# PERMIT

SEWAGE DISPOSAL SYSTEM

# PERMIT APPLICATION

RE: Proposed addition to existing dwelling  
6199 Lawyers Hill Road  
Building Permit #B00111879

PERMIT CARD

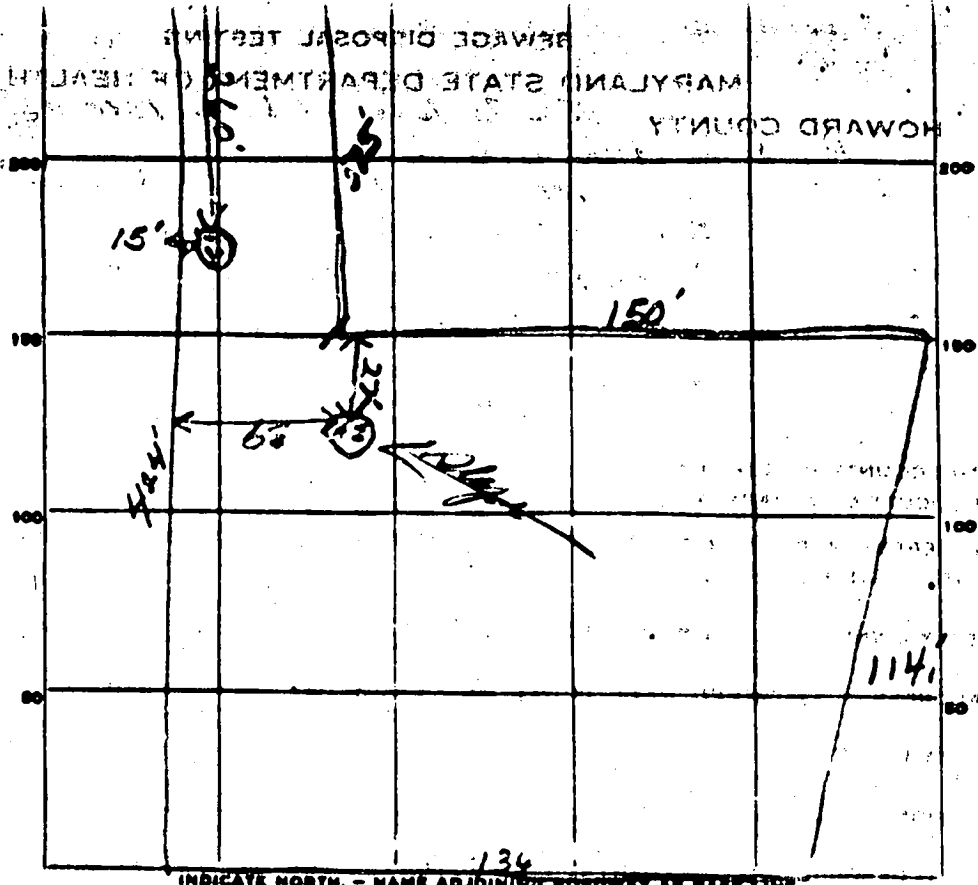
REMARKS: 4/24/73 - Drip Well is 9 ft deep

below top of bed Dry Well not yet installed

diameter of Dry Well is 9 ft.

Excavate tank & sewer lines & install sewer to

dry Well & Call for inspection. OK to cover

part of Dry Well B.H. Wood to cover into ground

entirely & leaving tank & entering into

**LOCATION SURVEY PLAT - HOWARD CO**

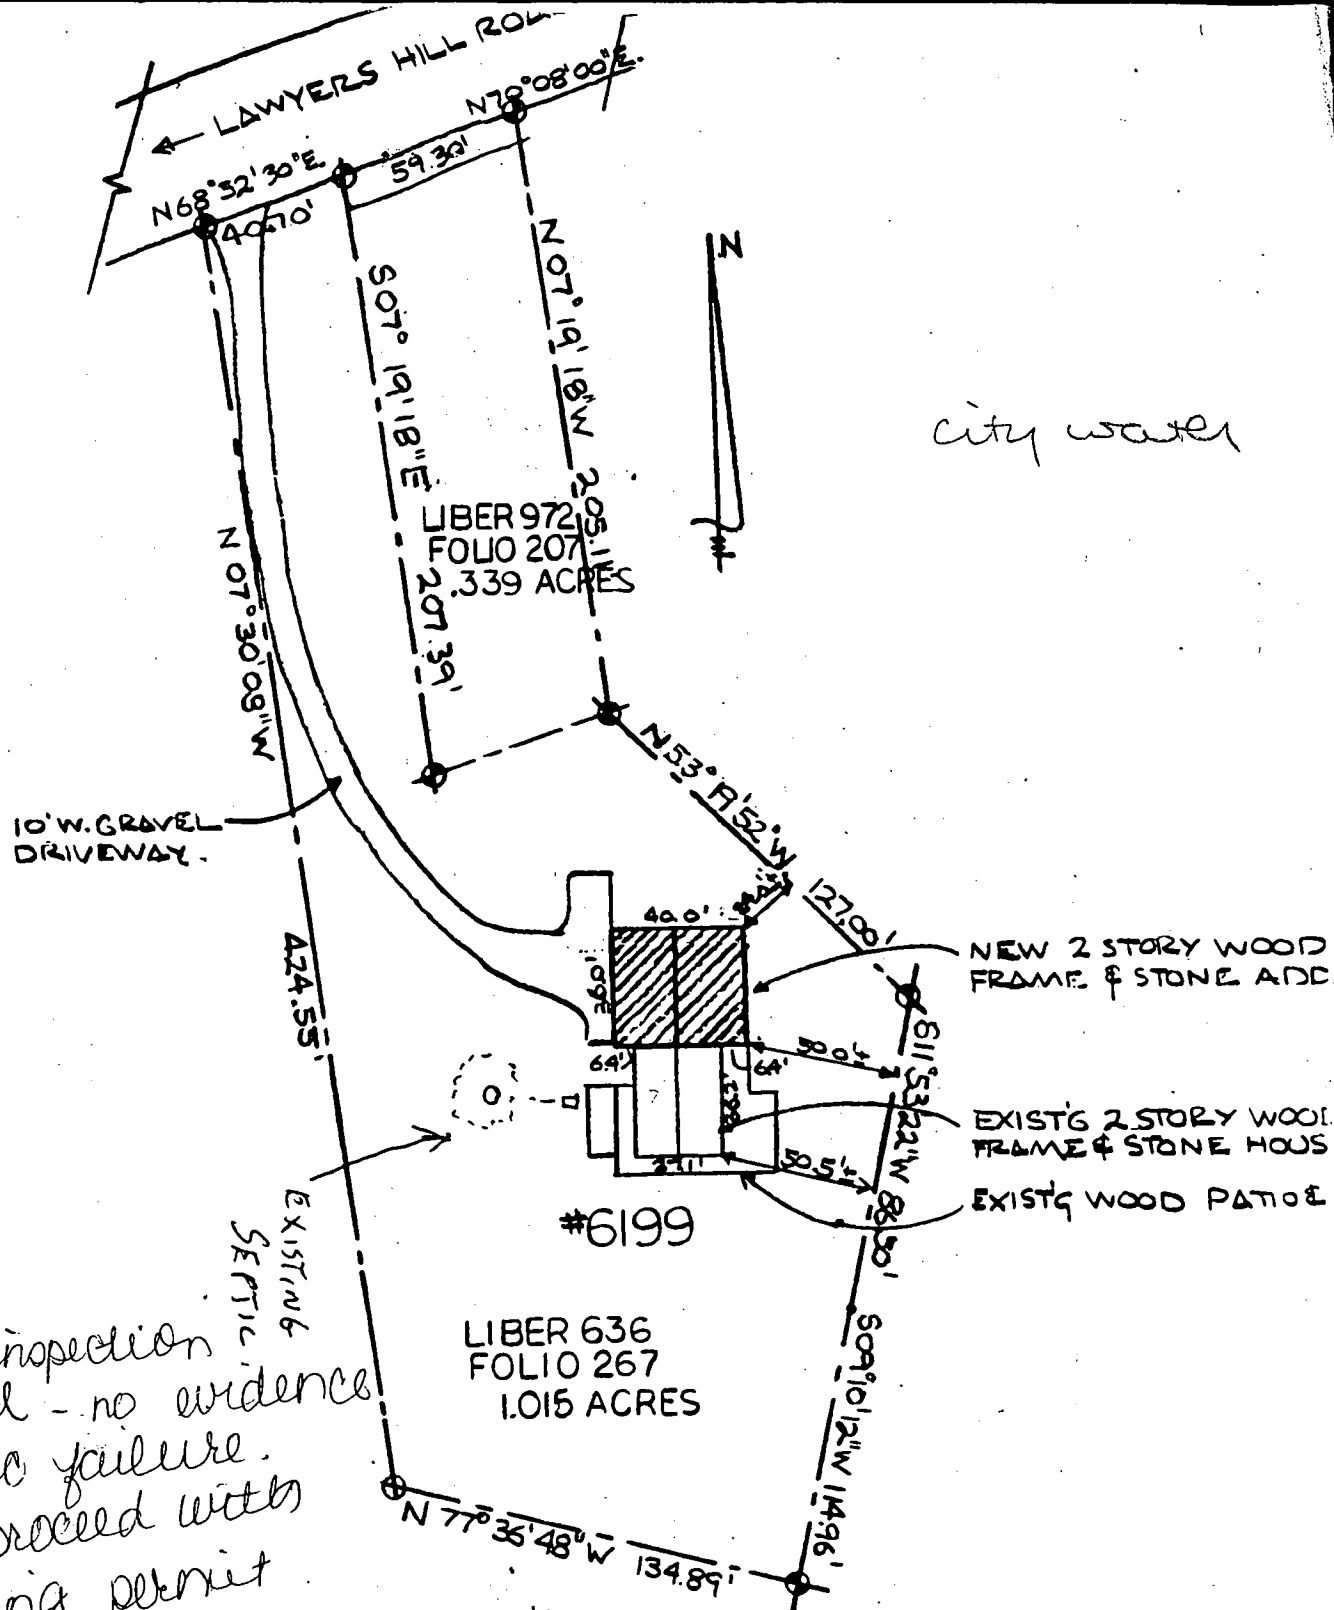
This office has recently received the above referenced building permit application; however, we are unable to approve the application at this time.

The proposal is to add supplementary bedrooms to the existing house. Any proposal for an increase in number of bedrooms in a house indicates potential increase in sewage flow. Health Department records of the septic system currently serving the existing house indicate a system sized for three bedrooms, installed in April, 1973. Therefore, prior to consideration for Health Department approval of the proposal, evaluation and upgrade of the existing septic system shall be necessary.

*3 new/  
BUT MOVING UPSTAIRS*

*2 BATHS  
CHANGING LOCATION OF 2*

6/9/98 site inspection performed - no evidence of septic failure. OK to proceed with building permit w/o septic upgrade at this time.
